Alert Service Bulletin B787-81205-SB290015-00 HYDRAULIC POWER - Ram Air Turbine System - Ram Air Turbine Pump And Control Module Assembly Replacement

Publication:	B787-81205-SB290015-00	Issue 002, 25 Nov 2014
---------------------	------------------------	------------------------

B787-A-29-00-0015-00A-00AA-D
Issue 002, 25 Nov 2014

Figure 1

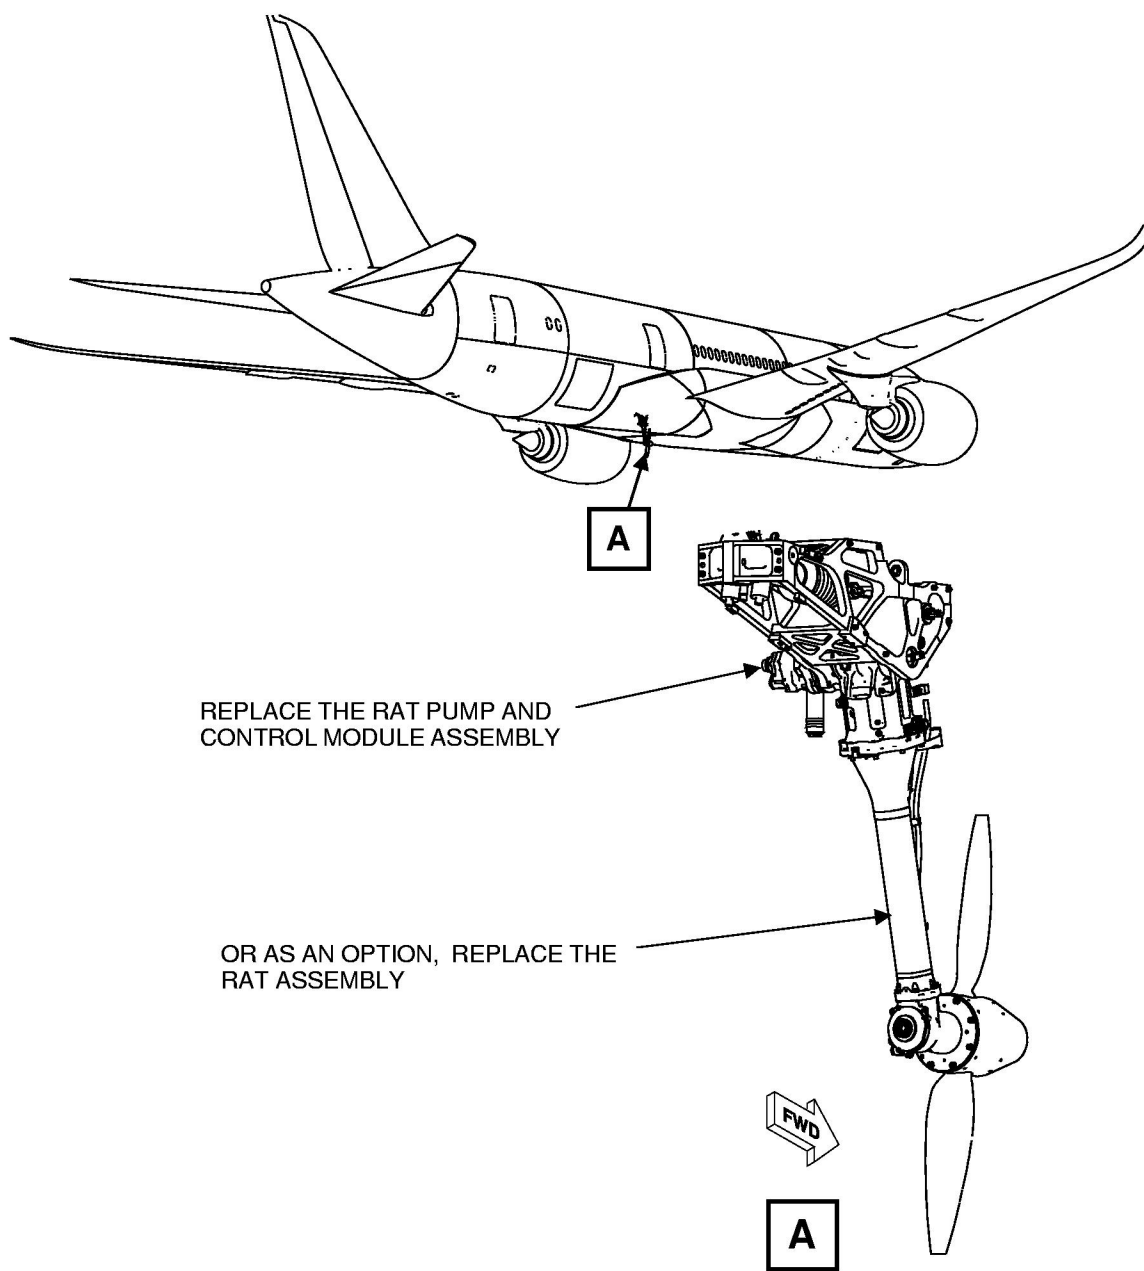
Replace the RAT Pump and Control Module Assembly or as an option, replace the RAT Assembly.
